21 July 2022

- 2.1 This report provides advice on urban design aspects of the proposal by Ryman Healthcare to construct a retirement facility at 26 Donald Street, extending through to Campbell Street in Karori.

Diagram 1: Typical south elevation, showing combination of window size, setback and sill height to minimise overlooking.²

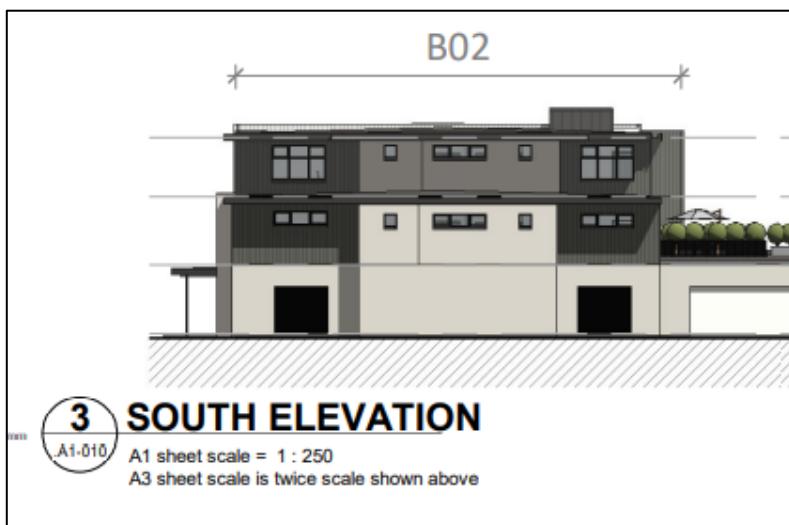
- 5.8.1 Some submitters are concerned about visual privacy and overlooking from the southern elevation of buildings B02 – B06, and some mention loss of privacy from building B01B.
- 5.8.2 There are relatively few living room windows on this elevation. At first floor level along this elevation the windows have a setback of around 6 metres, and at second floor level the setback is over 20 metres setback. (See diagram).

Diagram 2: Example of lower and upper sill views for second floor.

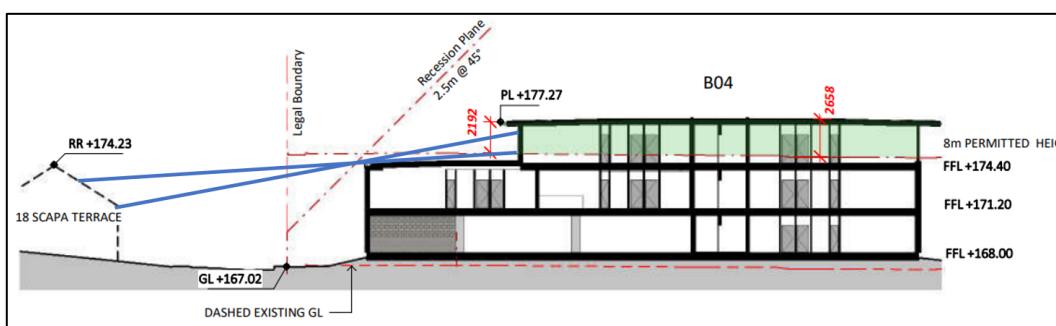
- 5.8.3 The first-floor level windows have raised sills and in order to look downwards out the window an occupant would have to be standing directly beside the window. These windows appear to have been included mainly to admit light and make the façade appear less blank, and would be very unlikely to contribute to overlooking or loss of privacy to adjacent sites. Decks at this level are either set back or proposed to have landscaping on the south side as screening.
- 5.8.4 Setback of the upper floor windows will address the issue of direct overlooking into rear yards, with the intervening roof form screening much of any view. By way of example, the possible views downwards from the upper floor window onto the property at 18 Scapa Terrace (and many others of similar type) are likely to be as illustrated by the blue lines on the section below (diagram 2).
